City of Suffolk
HISTORIC LANDMARKS COMMISSION

February 13, 2020

Subject: **REQUEST FOR CERTIFICATE OF APPROPRIATENESS HLC2019-00033**, submitted by Evelio Marulanda, property owner, for after-the-fact exterior alterations to property located at 131 Clay Street. The property is further identified as Zoning Map 34G18, Block A, Parcel 352, Suffolk Voting Borough, zoned CBD, Central Business District, and HC, Historic Conservation Overlay District.

Subject: **REQUEST FOR CERTIFICATE OF APPROPRIATENESS HLC2019-00047**, submitted by Justin Bush, Bush and Taylor P.C., property owner, for after-the-fact exterior and site alterations to property located at 205 Grace Street. The property is further identified as Zoning Map 34G18, Block A, Parcel 87, Suffolk Voting Borough, zoned RM, Residential Medium zoning district, and HC, Historic Conservation Overlay District.

PORCH HAND RAIL

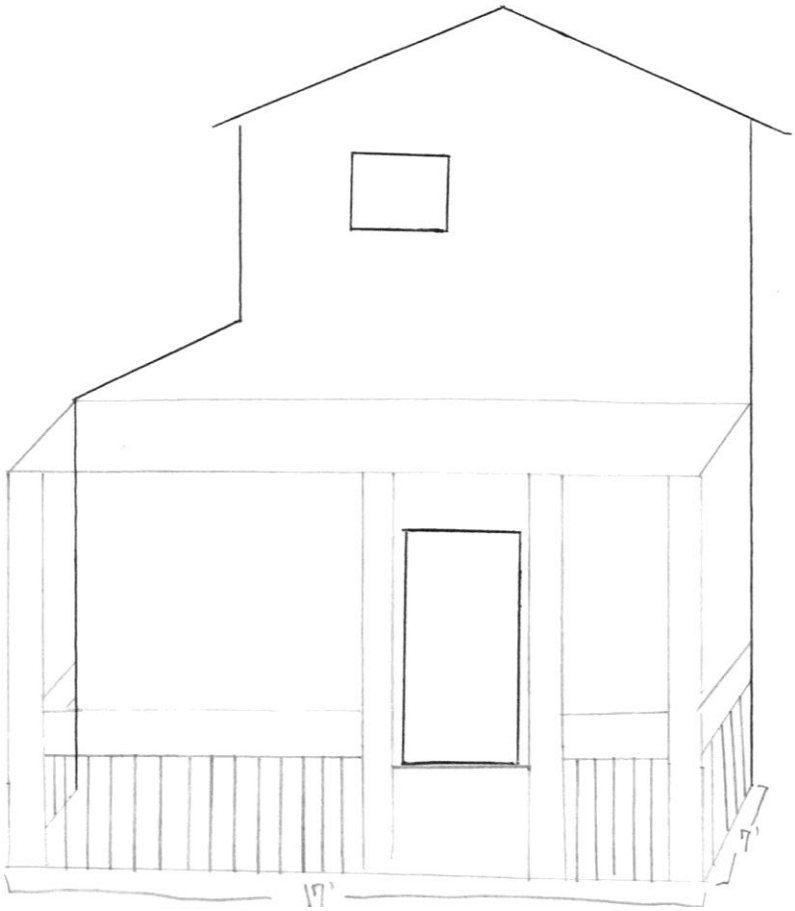
* INSTALL NEW HAND RAIL AROUND THE BACK PORCH 7'x 17' & PUT DOWN FLOORING WITH PINE DECKING BOARD.
Handrail Height 34" to 38" inches

The proposed covered rear porch is proposed to be constructed using four 6 x 6 treated wood posts with a wooden handrail to be 34” to 38” in height and consisting of square wood balusters; however, the height of the wooden handrail is required to be a minimum of 36” to meet building code. The porch will be built on the existing foundation and the porch floor will consist of pine decking boards. The porch will use the existing stairs for access, but the applicant has not proposed any handrails for the steps. All wooden elements are proposed to be painted white, which is the appropriate treatment of wooden elements within the Historic District. The porch is proposed to have a shed roof clad in black ribbed steel. Exposed fastener roofing of this type is typically used only on accessory structures but can be considered appropriate for a utilitarian back porch with lower visibility and clear separation from the main roof. It will also serve to differentiate the newly constructed rear porch from the main structure’s original features. The wood and metal materials proposed for the porch are modern but are compatible in type with the traditional materials that would be used for a historic residential building.

2. Create a covered rear porch, 17' x 7' in size, on the existing foundation as submitted. The covered porch is to have 6 x 6 treated wood posts with a wooden handrail that shall be a minimum of 36" in height, and a ribbed steel metal shed roof in black. All treated wood components of the rear deck shall be painted utilizing the color Outside White (CW712) or equivalent from the approved Williamsburg Color Collection.

NEW BACK PORCH

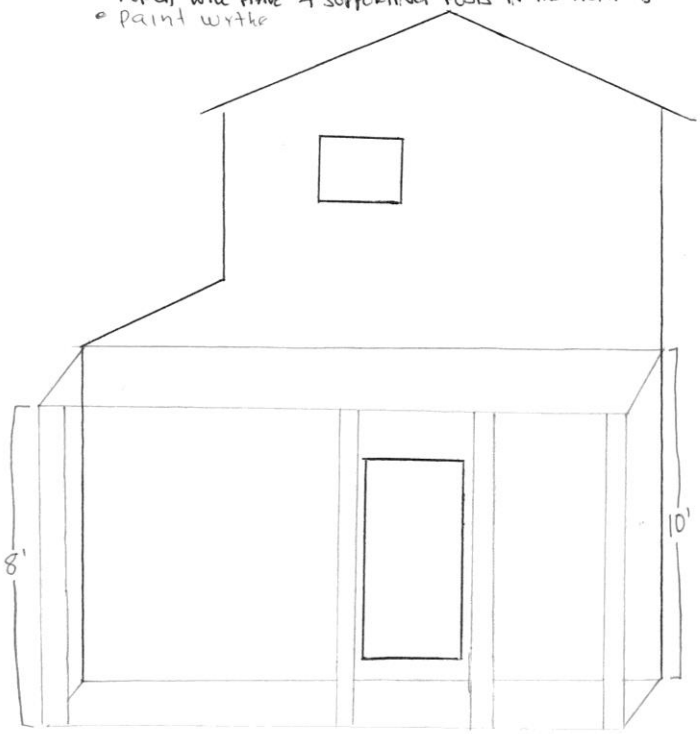
- METAL ROOF, WITH POSTS 4x4 & 2x6 SUPPORTING THE ROOF
- BACK OF THE PORCH WILL BE 10' TALL
- PORCH WILL HAVE 4 SUPPORTING POSTS IN THE FRONT 8'
- Paint white

REPLACE FRONT DOOR

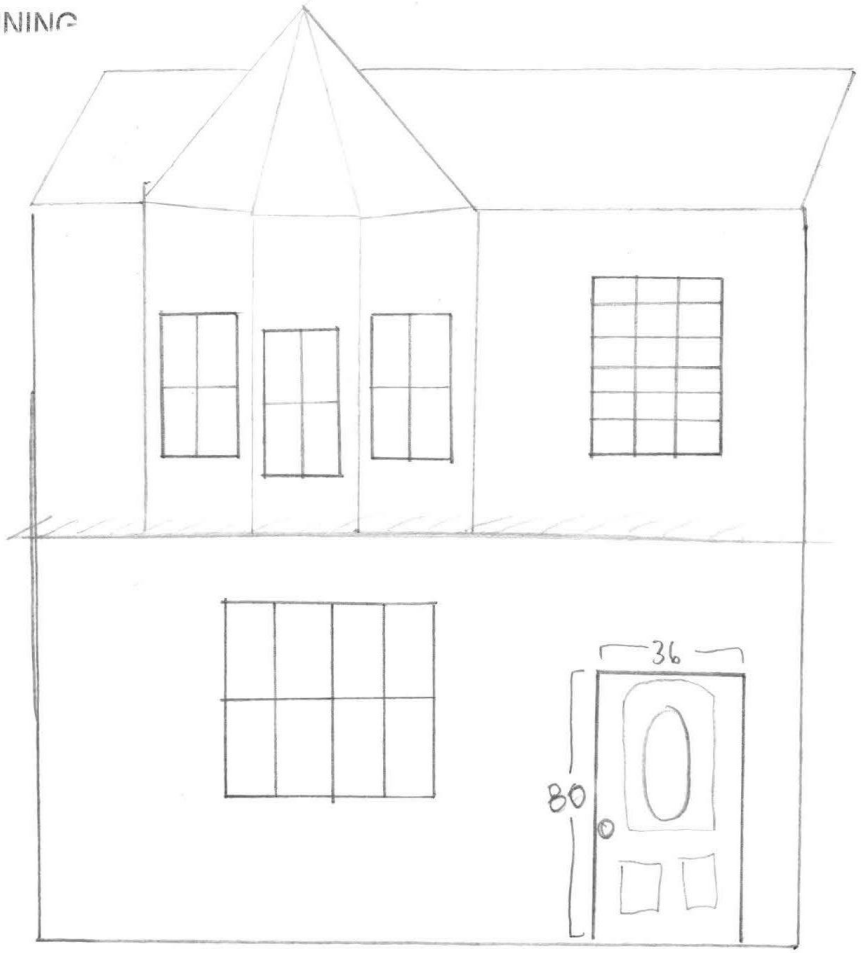
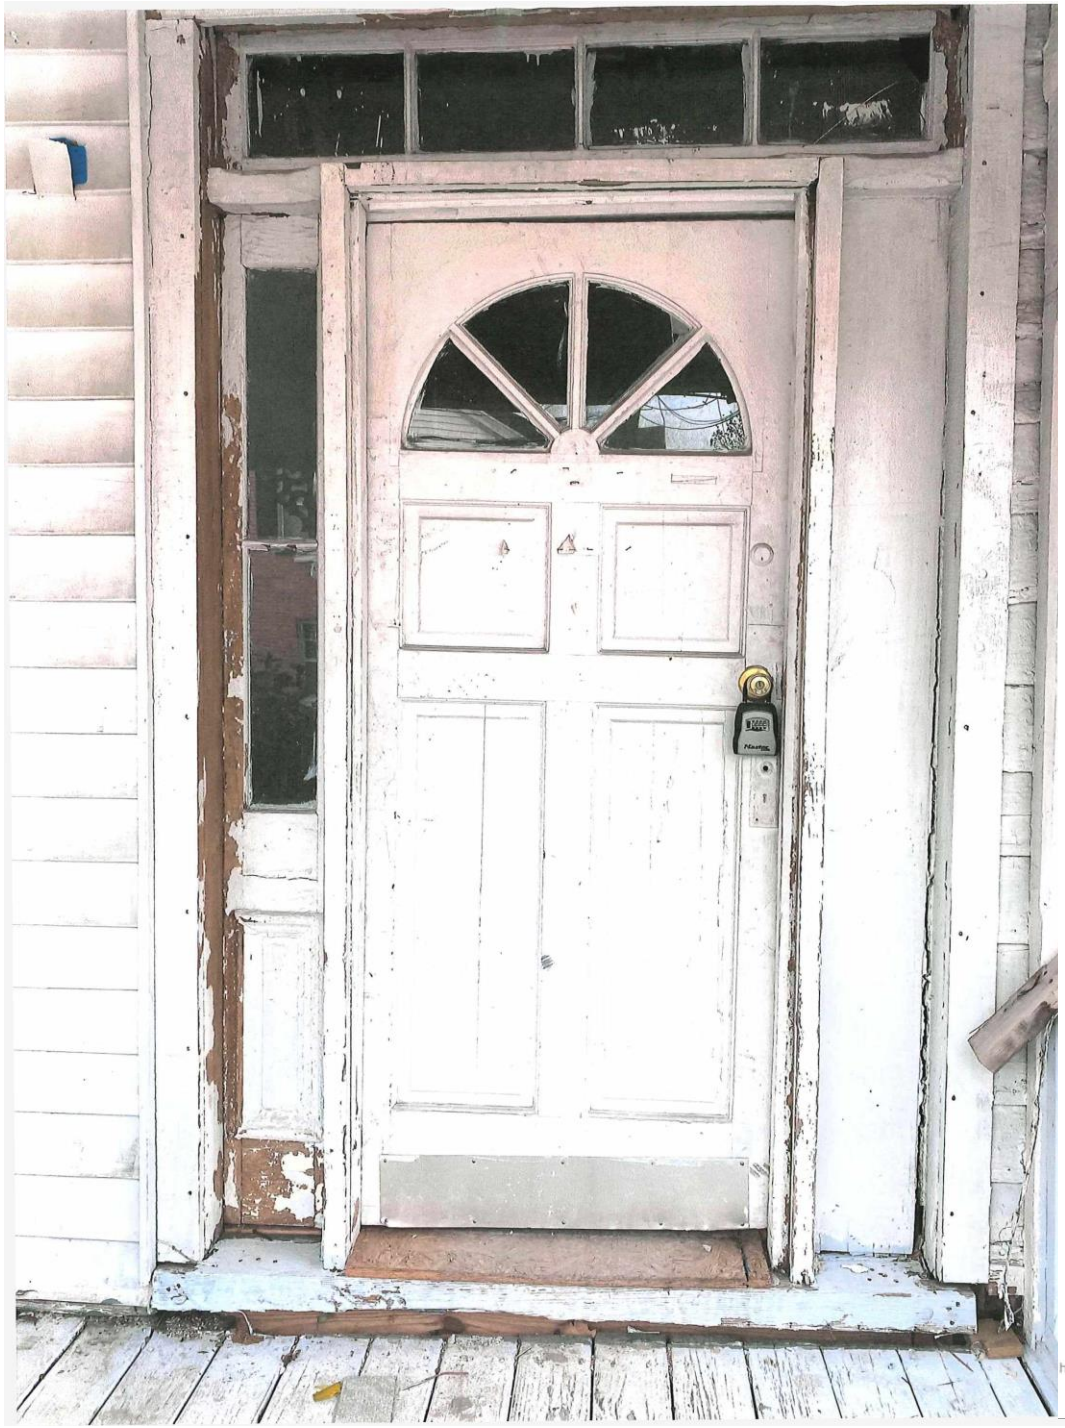
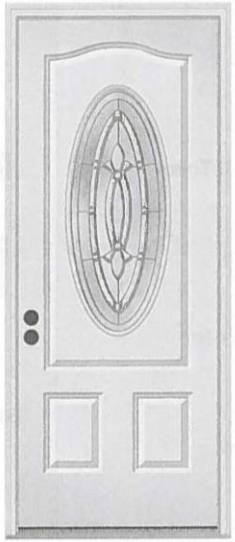
- IT'S IN BAD CONDITIONS & CANNOT BE FIXED
- THE NEW DOOR AS SHOWN BELOW WILL BE 36" x 80"

Along the front façade, the applicant is proposing to replace the existing single leaf wood front door with a new oval lite white steel door. The existing front door is a single leaf wood door with fanlight that was present at the time of nomination. It is proposed to be replaced although no documentation was submitted indicating that the wood door is beyond repair. The current wood

door is a historically appropriate door in material and design that does not appear to require replacement. It is recommended that the wood door remain and be restored as necessary.

3. Install a new oval lite white steel front door.

REPLACE SIDING THAT IS MISSING OR DAMAGED WITH WHITE VINYL SIDING - BOTH SIDES OF THE HOME, AS WELL AS THE ENTIRE BACK AREA NEEDS REPLACING.

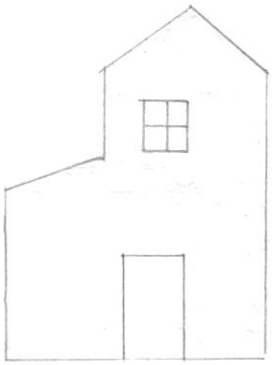
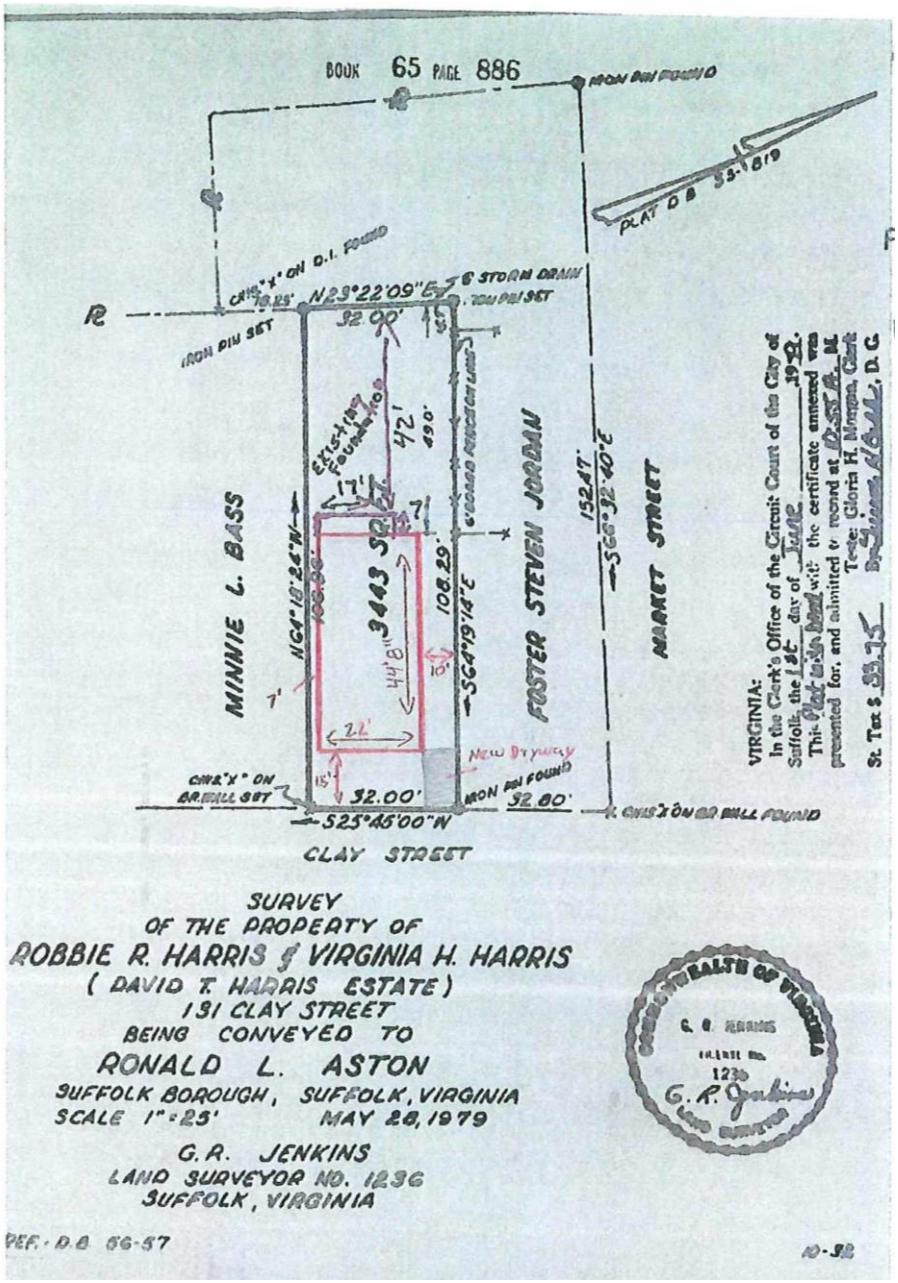
* GREY SHADED AREAS SHOW WHAT IS TO BE REPLACED.

7. Replace missing sections of white vinyl siding.
8. Replace two vinyl windows located on the second floor with two white vinyl clad wood windows.

9. Replace missing and damaged sections of white vinyl siding.

NEW VINYL SOFFIT
STORM DOOR
METAL WRAP
205
STORM DOOR
FIX STUCCO

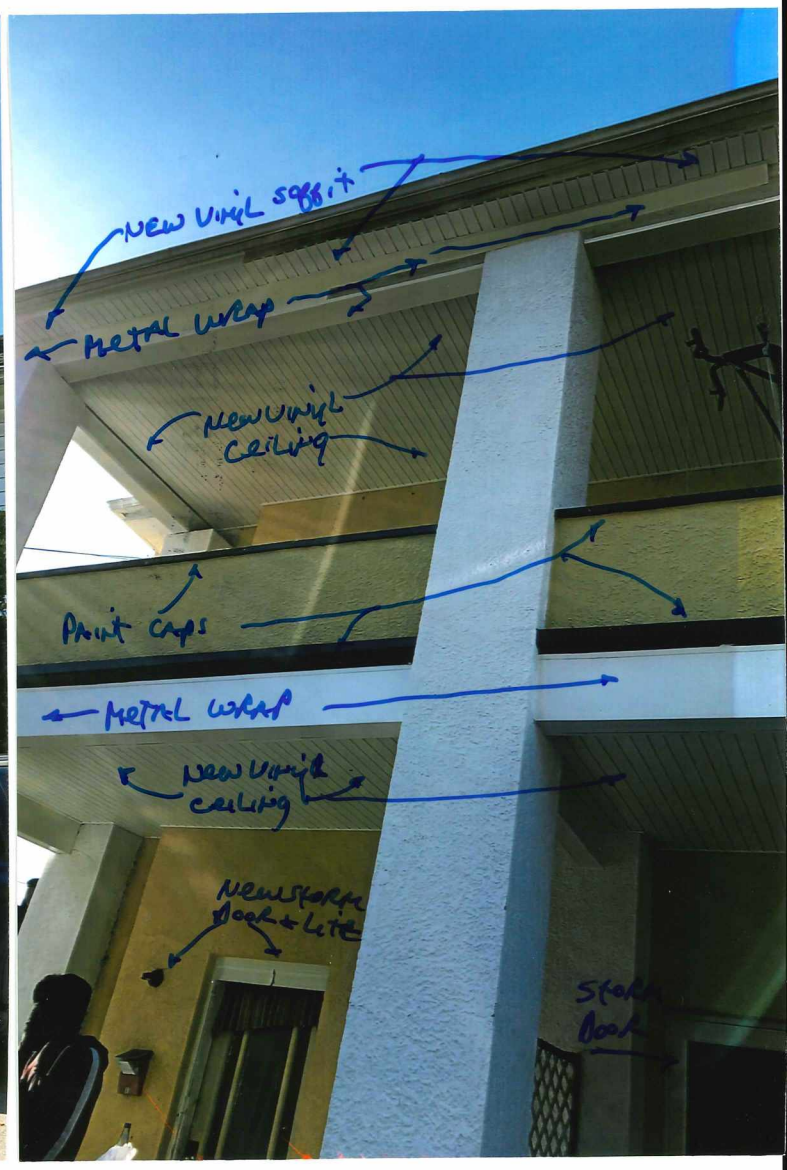
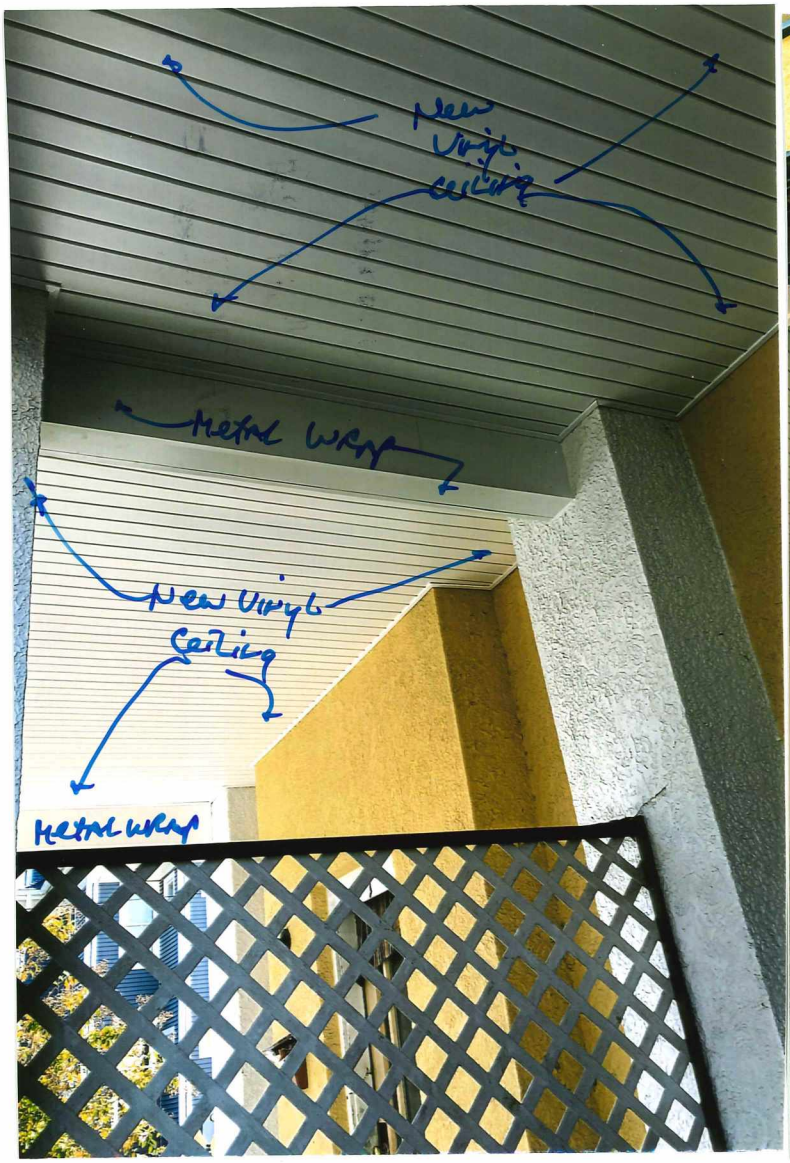
Along the primary façade of the subject property, the applicant is requesting after-the-fact approval to remove wood ceiling boards and soffits on the first and second floor and replace them with vented white PVC material that has already been installed. The applicant is also requesting to remove wood fascia boards along the first and second story and is proposing to replace them with like materials to be wrapped in white aluminum. Additionally, the applicant is requesting after-the-fact approval for the installation of a 6'8" x 25' trash enclosure located at the rear corner along the southern property line, which has been created by installing two sections of 6-foot-tall wooden fence with capped posts that abut an existing privacy fence.

A condition statement was submitted as part of the application that stated that the wood ceiling boards, soffit, and fascia boards were rotten due to water damage and beyond repair. The applicant is requesting to replace them with vented PVC materials on both the first and second stories. As stated above, wood elements should only be replaced when they are missing or beyond repair and the replacement should match the original in material and design. A substitute material may be acceptable for the replacement of original wood material if the Historic Landmarks Commission determines that the substitute or synthetic material will produce the overall character, appearance, and performance. Chapter 4, Section H.2. of the Historic District Design Guidelines, provides guidelines when determining the appropriateness of synthetic material and states that vinyl and aluminum siding is not acceptable as a substitute siding material. Moreover, vinyl has not been allowed to cover or replace wood materials except in cases where they existed at the time that a property was added to the District. Accordingly, staff recommends that the wood ceiling boards and soffit be replaced with like material and be painted white to match the existing color.

The applicant is also requesting to remove wood fascia boards on both the first and second floor of the primary façade and replace them with like material wrapped in white PVC materials. Additionally, the applicant proposes to repair a missing section of concrete located along the bottom right side of the second floor balcony. All sections of concrete below the second story balcony are also proposed to be wrapped in white aluminum to be continuous with the fascia. As previously stated, wood materials beyond repair should be replaced with like material. Metal is not an appropriate alternative material when replacing wood or when considering new siding or trim materials. Staff recommends that only the wood that is beyond repair be replaced with like material and be painted white to match the existing color. Additionally, staff recommends that the missing section of concrete be replaced as proposed but not be wrapped in metal.

Overall, the requested after-the-fact replacement of the first and second story wood porch ceiling boards and wood soffit with white PVC materials is not consistent with the Guidelines or actions elsewhere in the District; therefore, staff recommends denial of this request. Additionally, staff recommends denial of the request to replace wood fascia boards on the primary façade with wood wrapped in white PVC in addition to wrapping the concrete located at the bottom of the second story balcony.

3. Repair missing concrete located along the right side of the second floor balcony.
4. Replace missing knee wall caps on the first floor with new wood caps to be painted the same color.
5. Repair a section of stucco on the column closest to Bank Street with like material to be painted to match the existing color.
6. Install a white full view storm door on each unit door located on the front façade.
7. Replace existing or missing black jelly jar light fixtures at each unit front door with a new wall light fixture to match the existing in color and style.
8. Install two sections of 6-foot-tall wooden fence with capped posts to create a trash enclosure 6'8" x 25' in size extending from the existing fence located at the rear corner along the southern property line. The fencing is to be painted white.

* TRASH ENCLOSURE @ 205 GRACE ST. |

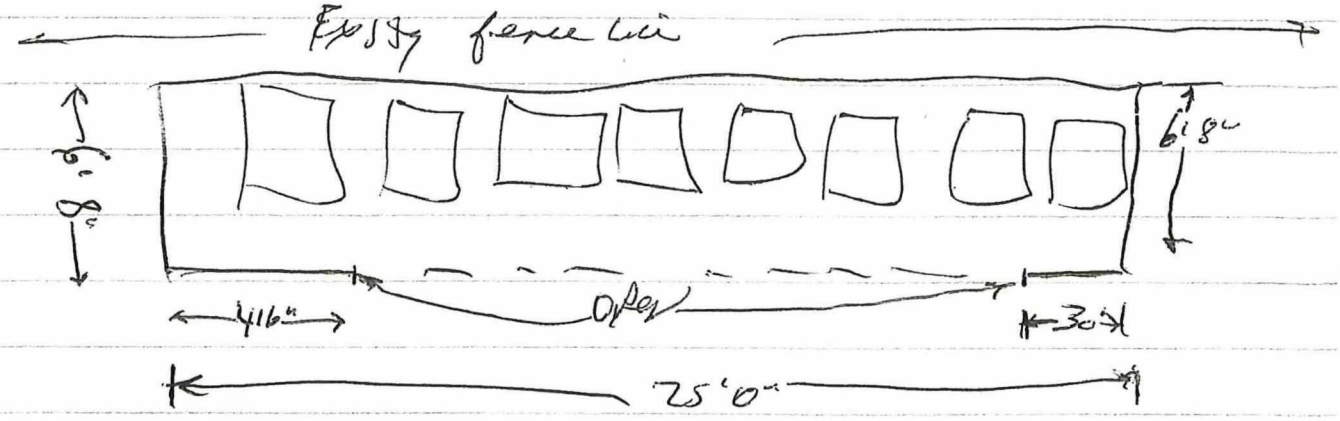
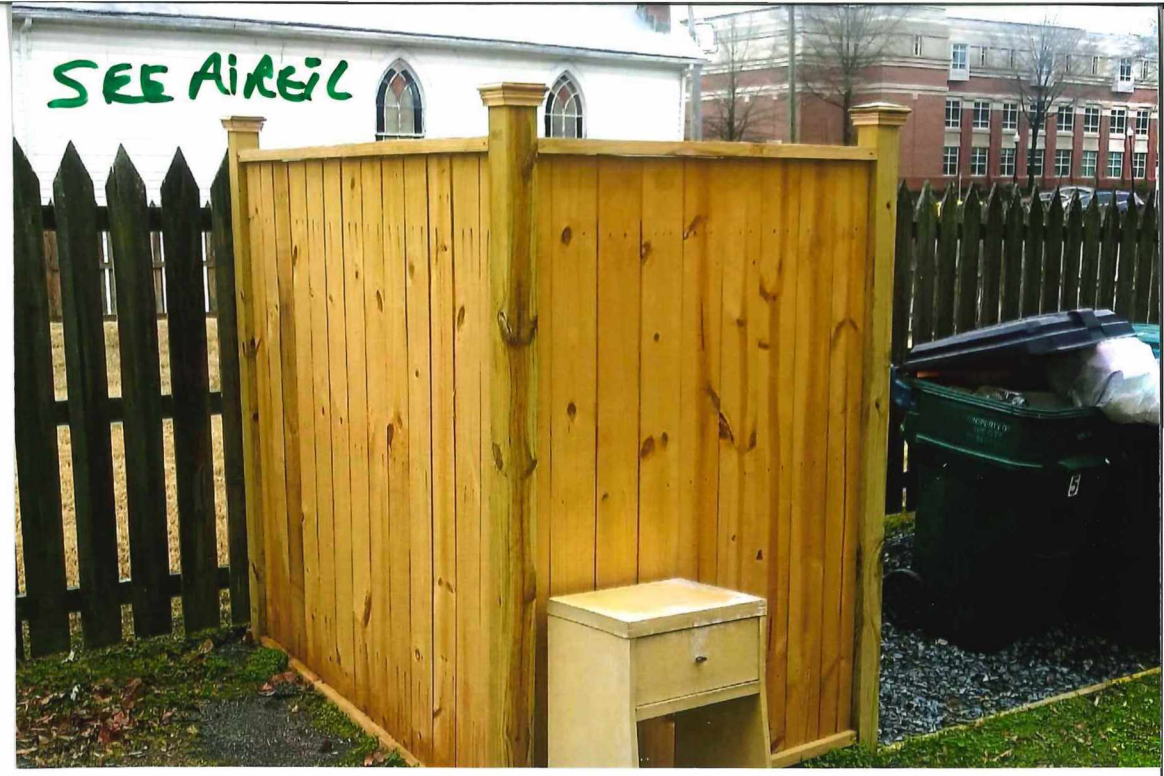
The applicant is requesting to create a trash enclosure at the southern rear corner of the property using two sections of 6-foot tall wood fence with capped posts at each end that connect to the existing privacy fence on the southern property line. The purpose of the trash enclosure is to provide an area to visually conceal 14 trash cans from the street. The trash enclosure is 6’8” x 25’ and the fencing is proposed to be painted white.
